# FIELD SERVICE BULLETIN

NO. 31  
MAY 9, 1947

SUBJECT: ENGINE MOUNT FRONT FRAME REINFORCEMENT

Figure 1. - Engine Mount Reinforcement

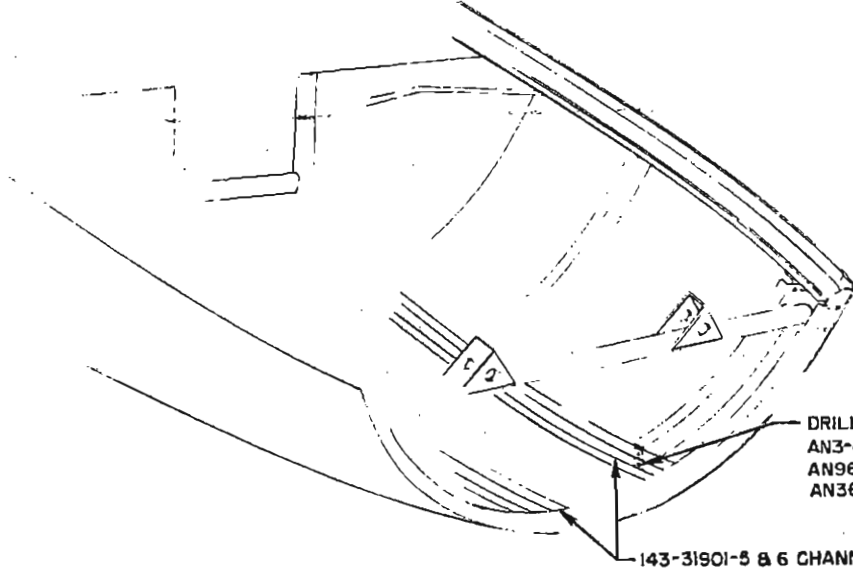
The front engine mount frames 143-31901-13, -14, and -17, have been found to develop fatigue cracks near the longeron. The required parts to reinforce these frames are contained in Kit 145-89035.

1. Place suitable stand under tail skid and chock the main wheels.
2. Remove the propeller.
3. Remove engine nose cowl and carburetor air scoop.
4. Support the weight of the engine by installing a brace under the propeller shaft or by a chain hoist.
5. Drill out the rivets securing 143-31901-13, and -14 frames and remove from engine section. See figure 1.
6. Remove the front engine mount tubular support.
7. Remove the two 145-31901-49 doubler plates from the aft side of frame 145-31901-17 at bolt hole for engine mount tube.

8. Clamp 143-31901-53 and -54 doublers to the aft side of 143-31901-17 frame aligning the flanges of the doubler against the frame flange and longeron.
9. Drill through the 143-31901-17 frame (on the vertical face) and longeron with a No. 21 (.159) drill. Install rivets

10. Drill the 5/16 inch bolt hole through the installed doubler.
11. Draw a center line on the outboard flange of the new 145-31929-1 and -2 frames.
12. Position the front engine mount tubular support before installing 145-31929-1 and -2 frames.
13. Clamp the new 145-31929-1 and -2 frames to the longeron and 143-31901-5 and -6 channels, with the flange center line on the existing skin rivet holes.
14. Drill No. 21 (.159) holes through skin rivet holes and 143-31901-13 and -14 frame flanges, being careful not to elongate skin rivet holes.
15. Drill No. 12 (.189) holes through the upper and lower flanges of the 145-31929-1 and -2 frames. Install AN3-4 bolts, AN960-10 washers, and AN365-1032 nuts.

NOTE: At first rivet hole below longeron frame 145-31929-1 install DR-143A-16 Du Pont explosive rivet. If the existing doubler spot welded to the top side of the longeron interferes with the installation of the AN3 bolt, trim a washer and install under the bolt head.

16. Secure the front tubular engine mount cross-rod using two AN5-25A bolts, two 483-D516-17 spacers, two AN960-516 washers and two AN365-524 nuts. Place the spacers between the front frame and the tubular cross-rod.
17. Compliance with this Bulletin must be entered in the airplane log book.

NOTE: Torque the engine load mount bolts to 450-500 inch pounds.
